GLOBAL ENERGY CONSULTANTS, LLC

Attachments: Appendix A: Professional Information on Mr. Thomas A. Jones
Appendix B: Marked Pages from NUHOMS FSAR

Subject: Direct-to-Final Rule on Amendment No. 5 to CoC No. 1004

The above referenced proposed direct-to-final rule seeks to amend the regulations to revise the Standardized NUHOMS cask system to incorporate NUHOMS-32PT DSC under Amendment No. 5 to CoC Number 1004. We have examined the underlying technical material (the revised Technical Specification, the SER, and TN West's FSAR) and have determined that:

Figure 4.2-6
Prefabricated NUHOMS® Module Longitudinal Section

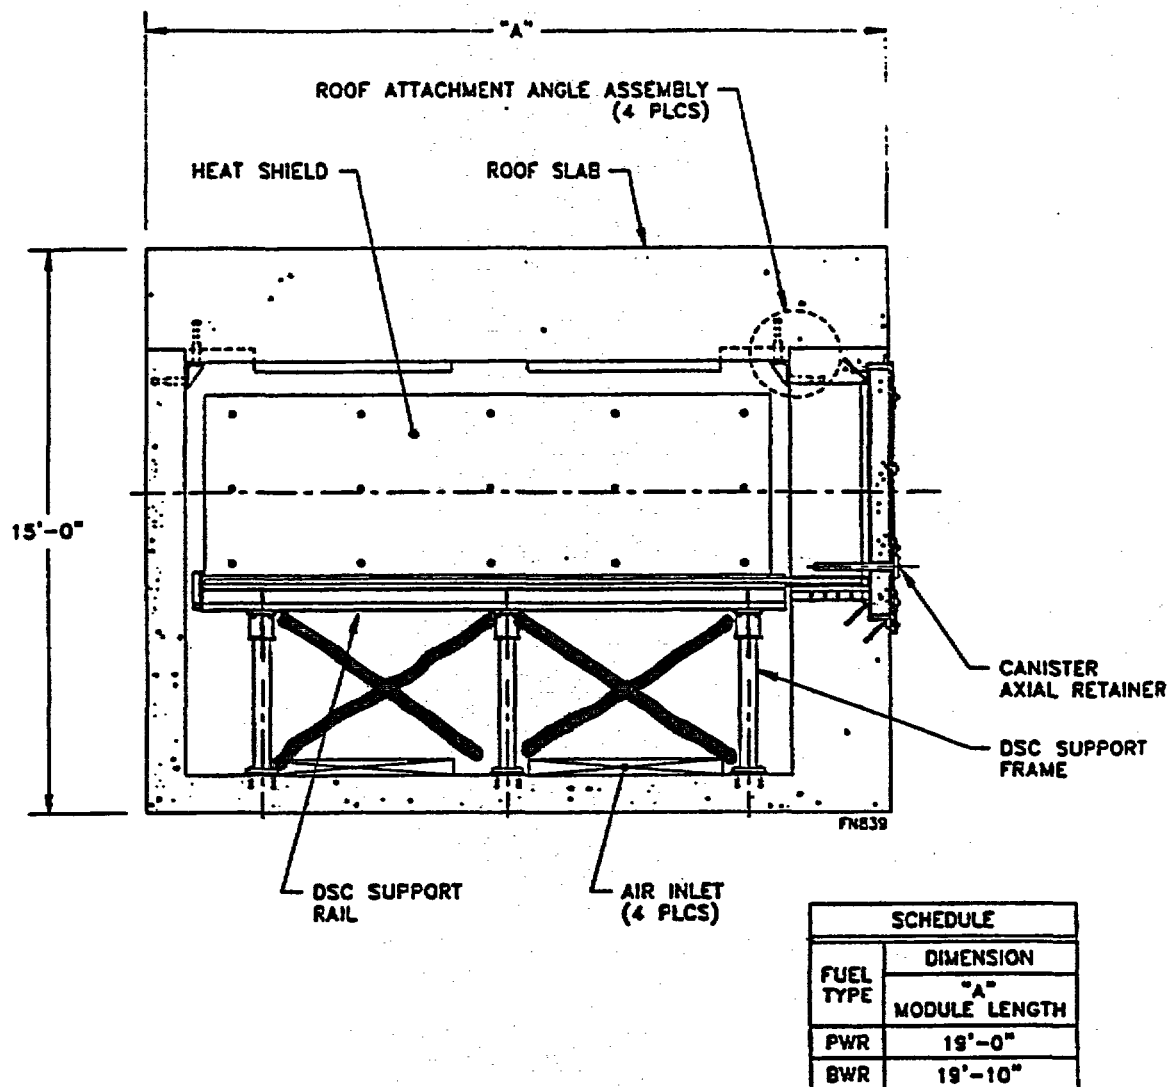
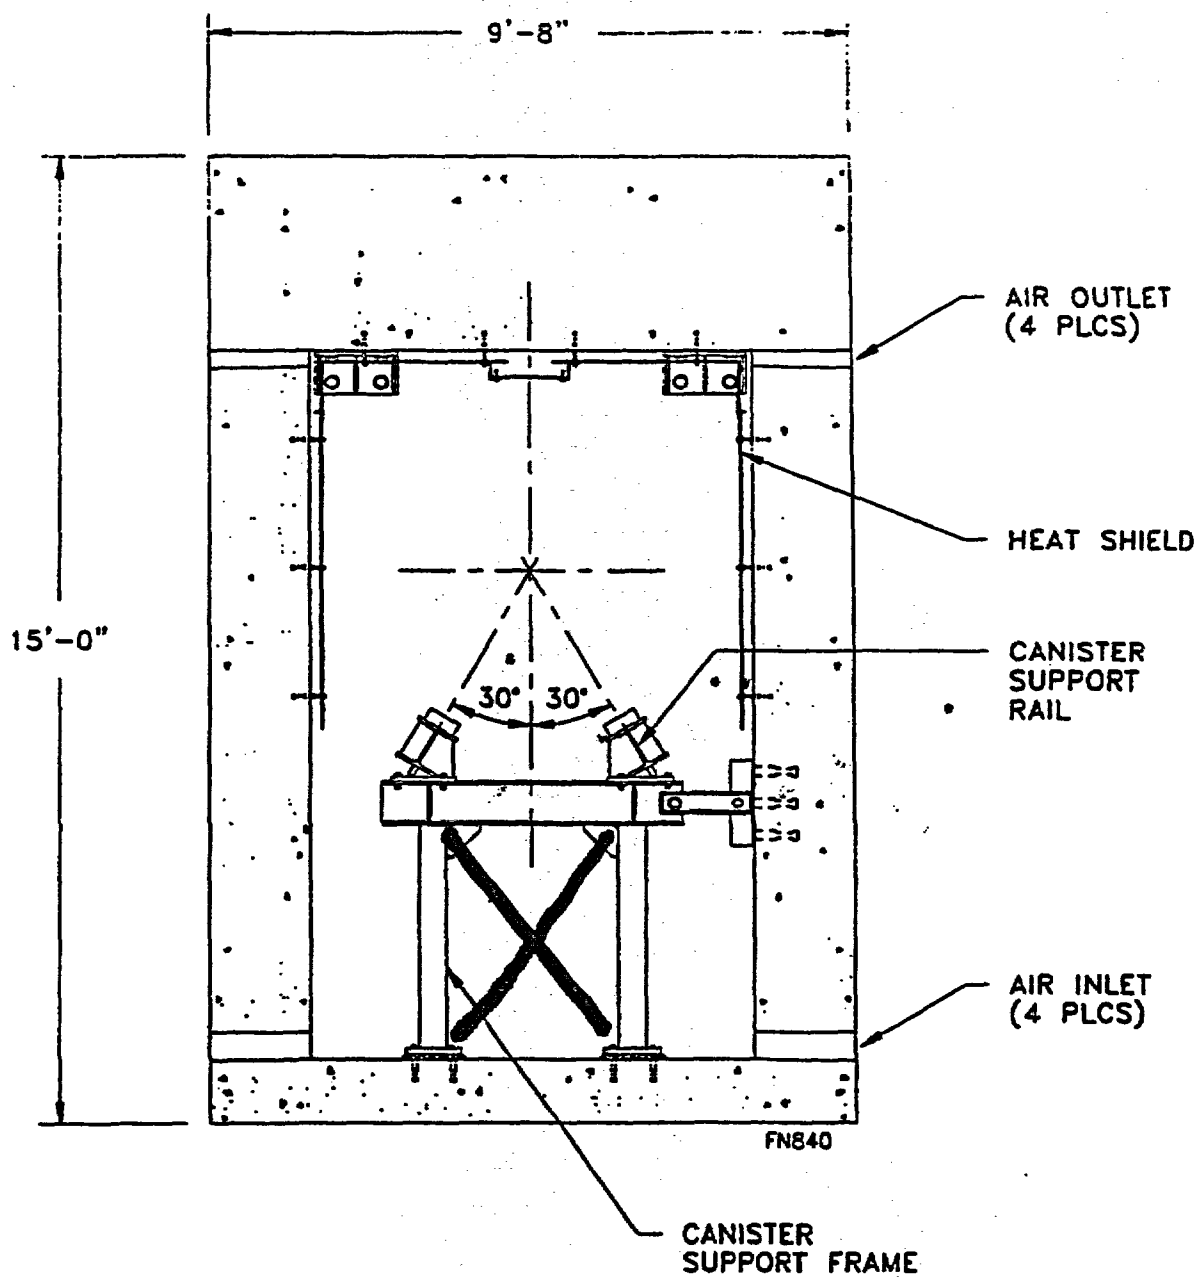
In Appendix B, I have placed a marked copy of the pages from the FSAR [4], where I have marked (in felt pen) the missing braces.

The consideration of the tornado-borne missile in the FSAR [4] is equally oblivious to the real vulnerability of the HSM. The entire three-foot thick top roof is held by a mere four anchors about 1-1/2 inches diameter and the concrete-filled front door (over 7,000 lbs. in weight) is not even held by bolts (rather, by three straps). The FSAR [4] provides no analysis of the integrity of these weak locations in the HSM under natural environmental phenomena loads. (How these structural features will resist a larger impact such as a plane should also be a matter of concern to the agency in the after-9/11 world.)

Figure 4.2-8
DSC Support Structure

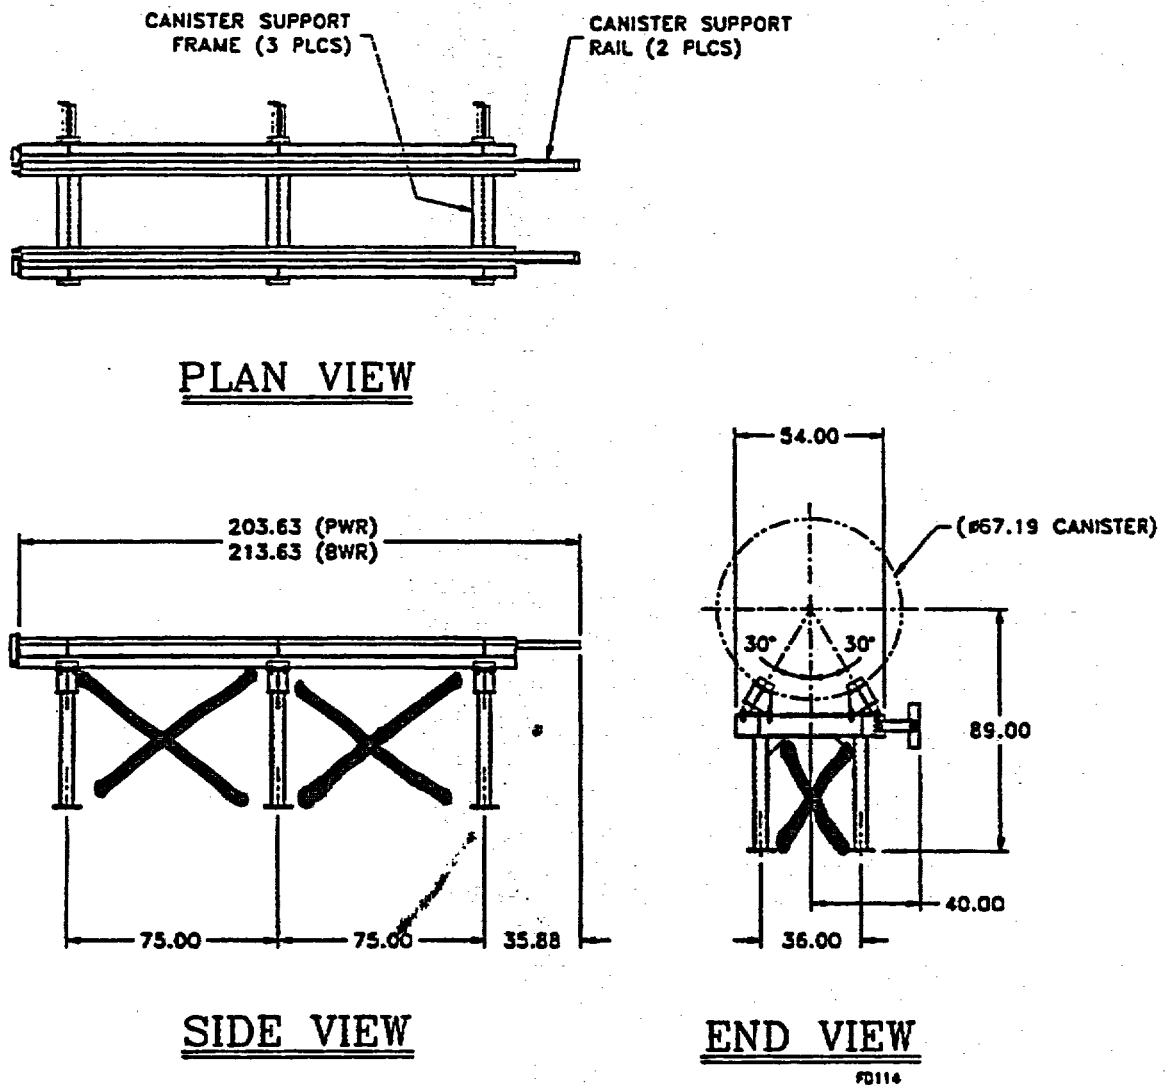
Further, it is noted that the 32PT DSC is the heaviest canister proposed for use thus far in the HSM. NUHOMS's FSAR asserts that the DSC support structure is braced, presumably to incorporate seismic resistance. A review of the sketches provided in the FSAR show no bracing.

Without the braces, the DSC support structure in the HSM is weak against axial or lateral overturning moments, especially the increased g-loads that will accompany the heavier 32PT DSC.

DETAIL 2 (2x8)

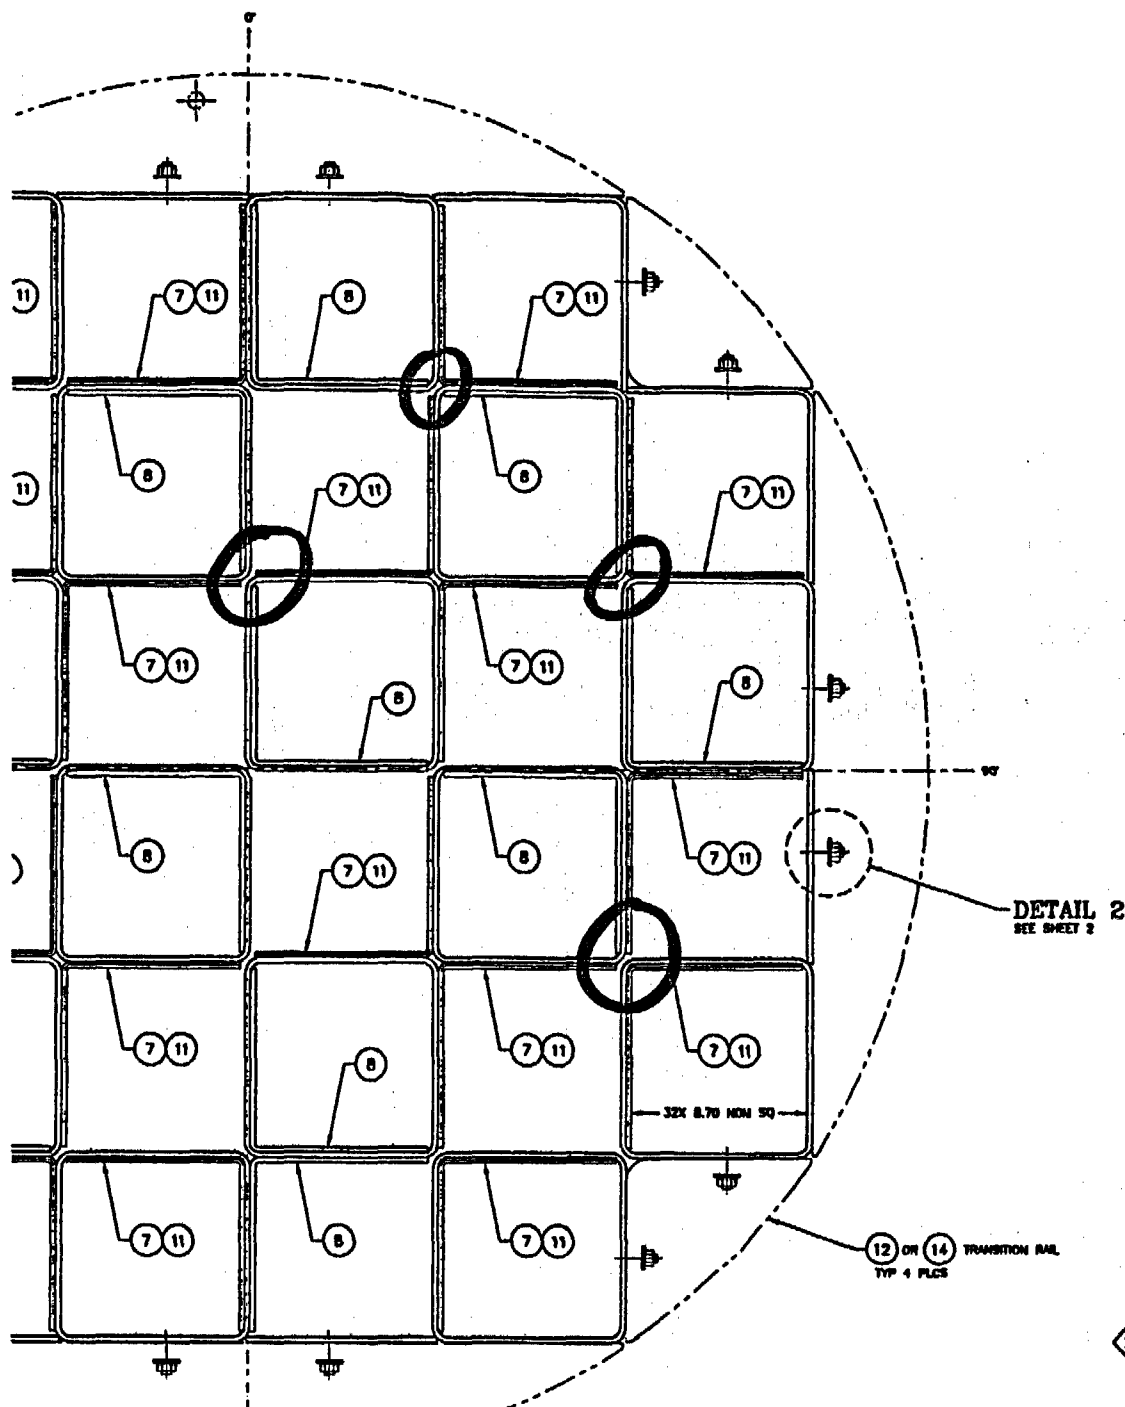
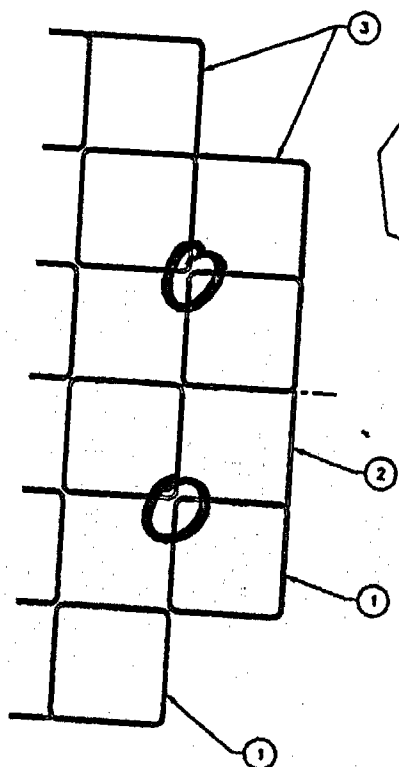
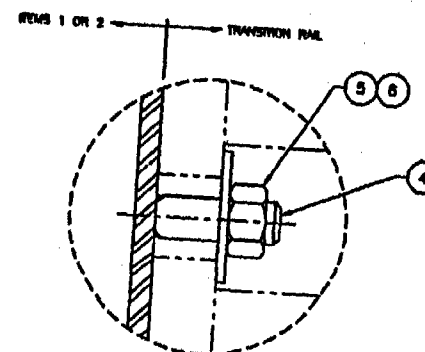
Of an even greater concern is the clear absence of critical structural welds in the fuel basket in DSC 32 PT. I have manually circled areas in the limited drawing details released to the public that show absence of welds in the fuel basket at critical load transfer locations under a horizontal drop condition (see Appendix B). TNW's stress analysis of the basket appears to have a serious error – perhaps an erroneous assumption in the finite element model. Critical stress analyses figures are deleted from the non-proprietary copy; therefore, I cannot provide further help.
